A G E N D A
FARRAGUT MUNICIPAL PLANNING COMMISSION

June 19, 2014
7:00 p.m. Farragut Town Hall

SUBJECT: Discussion and public hearing on a preliminary plat for the Split Rail Farm Subdivision, formerly known as Everett Hills and Karastone Farms, Parcels 98, 98.01, and 98.02, Tax Map 142, Zoned R-1 and OSR, located on the west side of Everett Road approximately 2,500 feet north of Smith Road, 50.80 Acres, 73 Lots (Farmstead Developments, LLC, Applicant)

**SUBJECT: STAFF COMMENTS ON PRELIMINARY PLAT FOR SPLIT RAIL
FARM SUBDIVISION**

PROPOSED CONCEPT PLAN

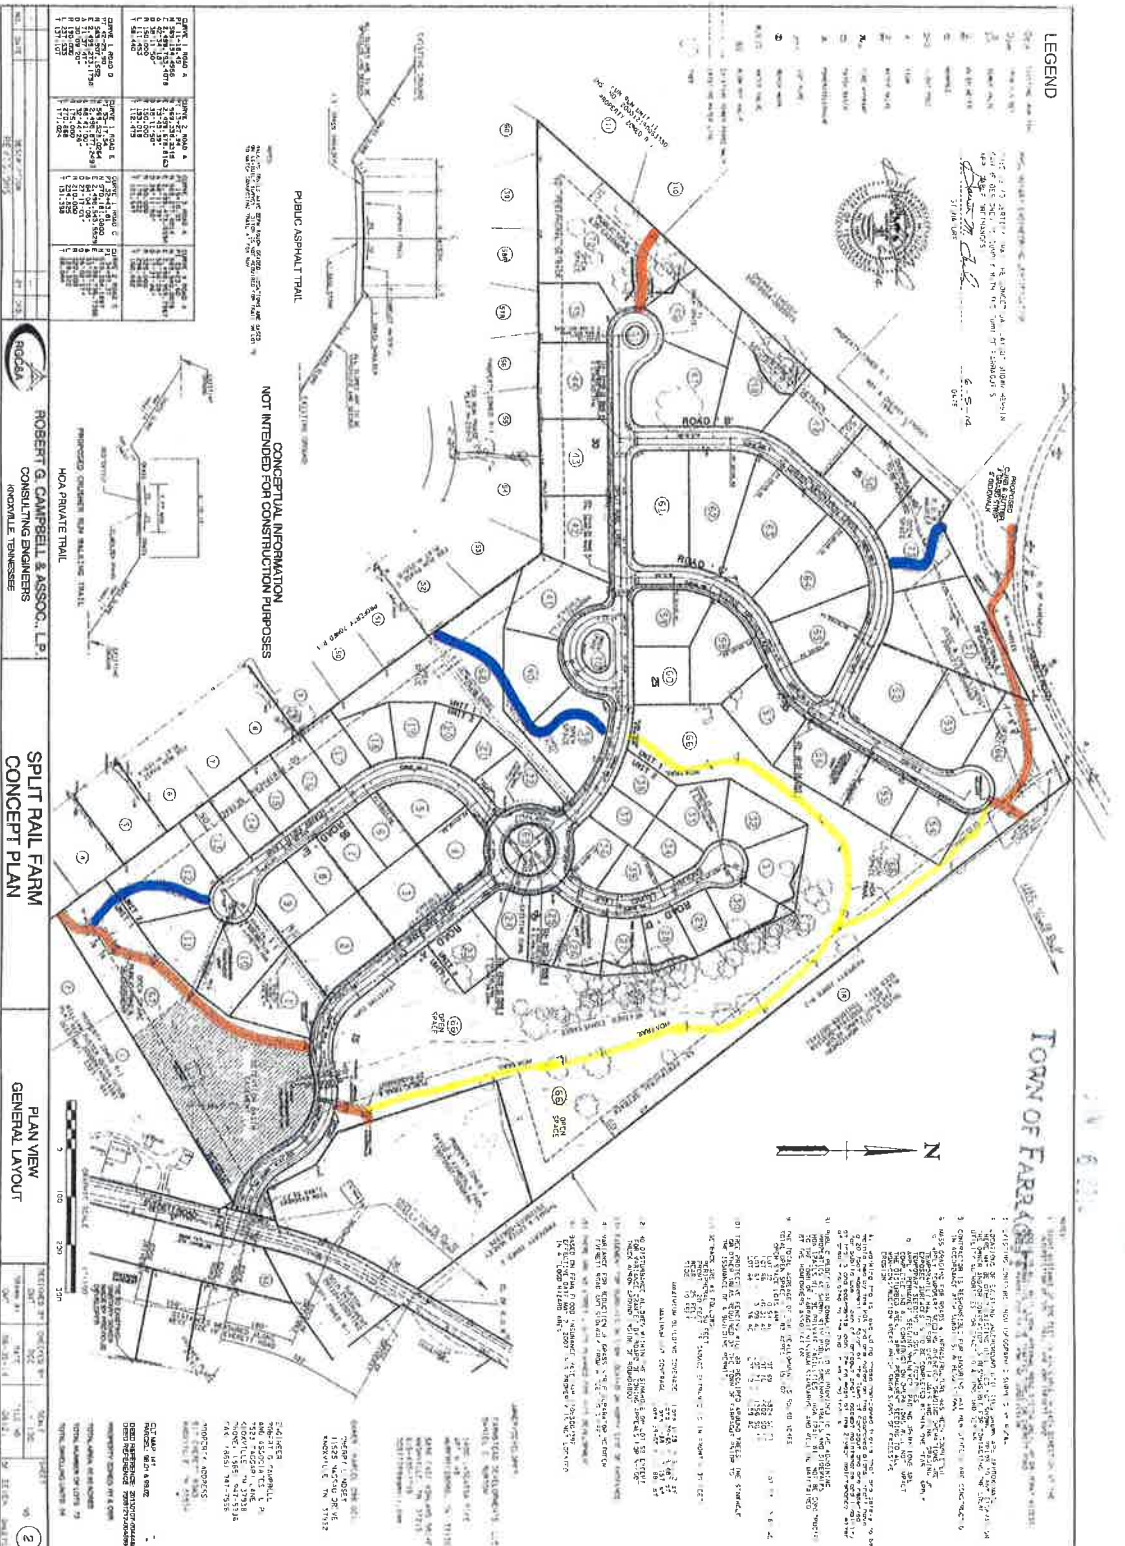
already been installed along these trail sections. Though these are proposed as private trails, the staff would recommend that precast concrete headwalls be used, similar to public trails, in order to lessen the potential for soil subsidence and erosion around the pipe edges. This and the request for accepting pea gravel trails will need to be discussed at the meeting.

RECOMMENDATION: Aside from any remaining technical comments related to the plan and that will be provided at the meeting, the staff would point out that, as indicated above, a number of previously approved public walking trail sections are either being proposed for removal or converted to private trails to be maintained by the homeowner's association. This development is zoned R-1/OSR and the common open space is required to be "pedestrian friendly." Similar to a clubhouse, pool, tennis court or some other amenity to serve a development, a private trail system is an option that the planning commission may consider toward fulfilling a recreational component of common open space. However, since these are linear and have more than one access point and will interface with trails proposed for public use, the staff could envision problems with regards to how these are used. These private trails will inevitably be used by some individuals that do not live in the Split Rail Farm Subdivision and the staff could envision the homeowner's association requesting that these pea gravel trails, since they are also being used by the public, be taken over by the Town in the future when maintenance issues start to arise.

Though the planning commission may approve the private trail system proposed, how these could be used and would be maintained in the future needs to be very clear. The staff would note that if the private trails and the headwalls associated with such trails, as proposed by the applicant, are approved, there needs to be language on the concept plan, preliminary plat, and final plat(s) which clearly indicates that these trails do not meet the Town's standards for public walking trails and, consequently, would be the responsibility of the Split Rail Farm Homeowner's Association to maintain in the future.

PRELIMINARY PLAT

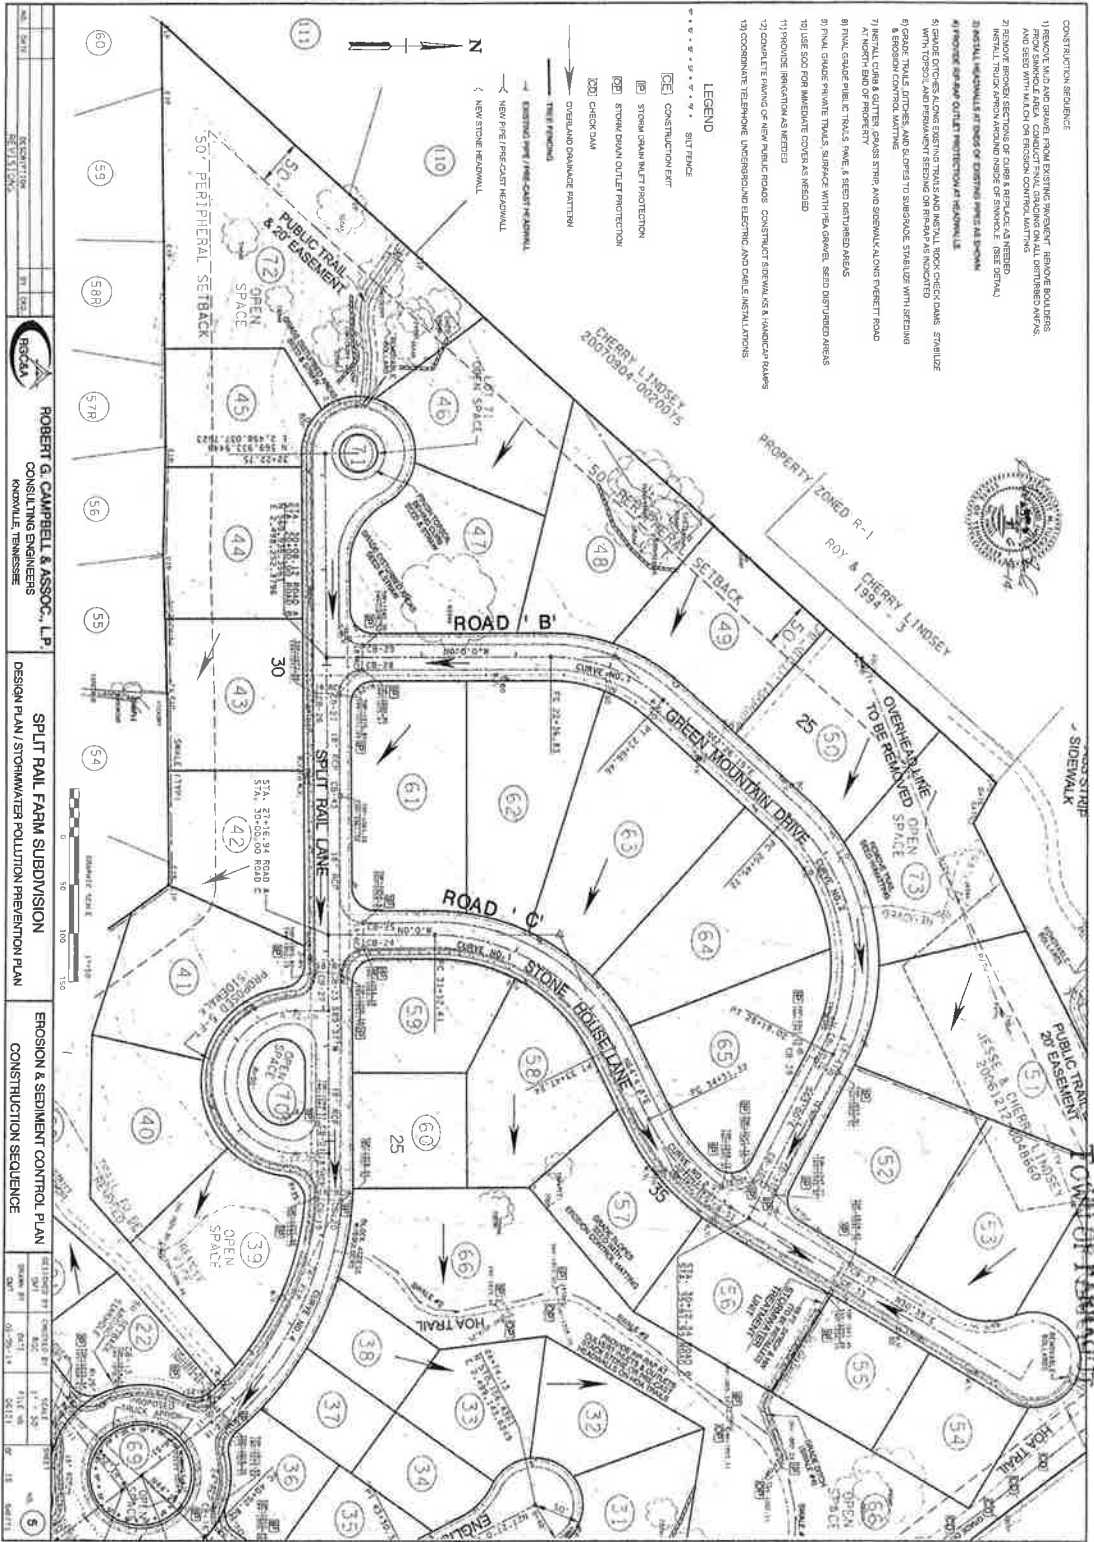
- 3) Please submit Page 15 of the preliminary plat;
- 4) Please reprint the cover page of the preliminary plat so that all information is legible (the address for the engineer was blurred);

EROSION & SEDIMENT CONTROL PLAN
CONSTRUCTION SEQUENCE

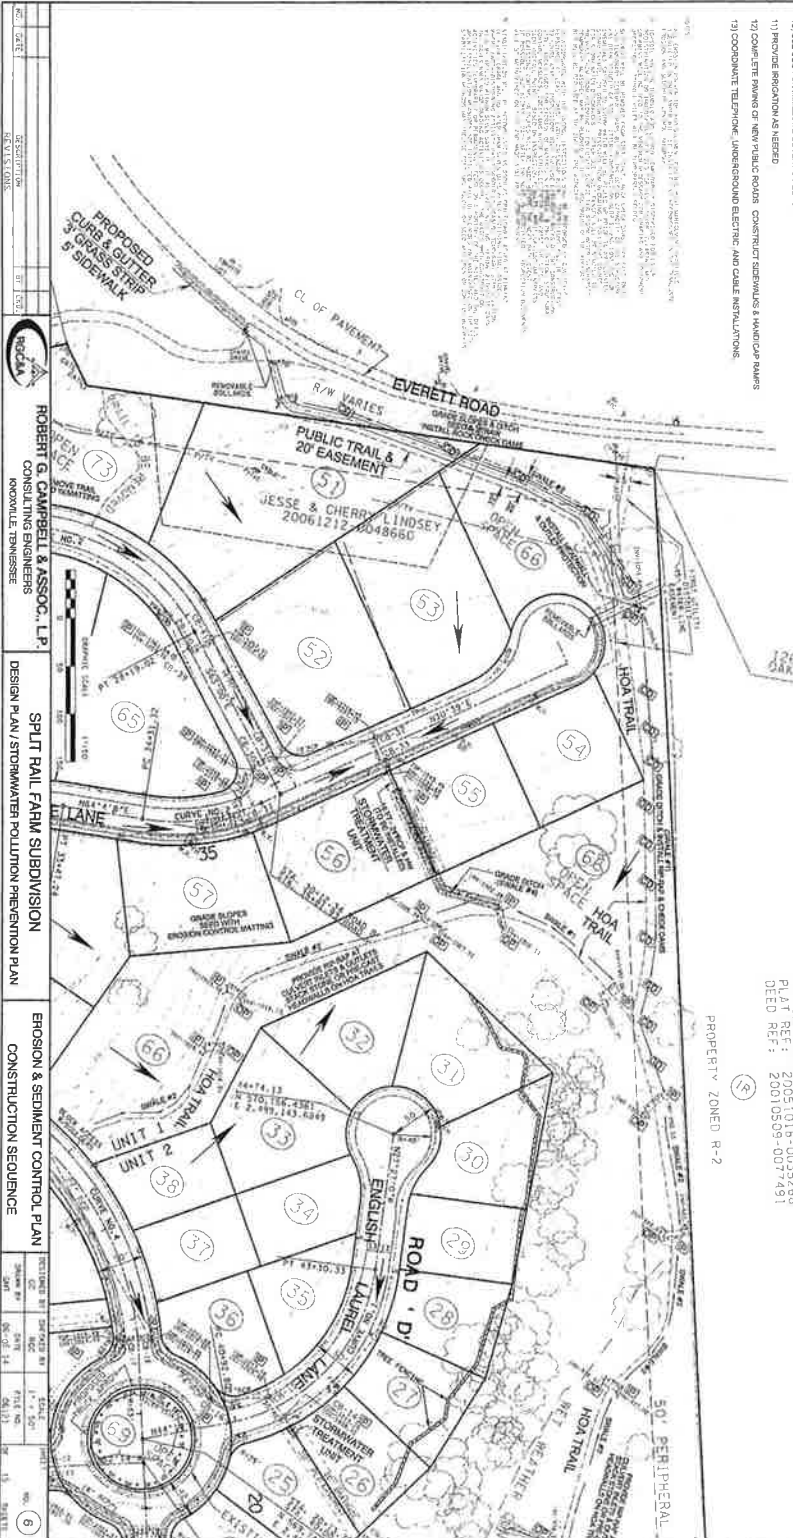
- 12) The HOA Private Trail detail reflects grades adjacent to the walking trails to be 2:1. The adjacent trail grades must be revised and designed to Town standards. The Town does not permit any finished slopes (whether associated with public or private trails) steeper than 2.5:1;

- 19) This revised plat increases the number of buildable lots somewhat, and develops some trails as "HOA maintained," as opposed to public trails to be maintained by the Town. These HOA trails show steeper slopes than are permitted and use rip rap in lieu of headwalls at pipe ends. No slopes steeper than 2.5:1 are permitted and the staff would recommend drainage structures, regardless of the type of trail, be consistent with the Town's requirements;
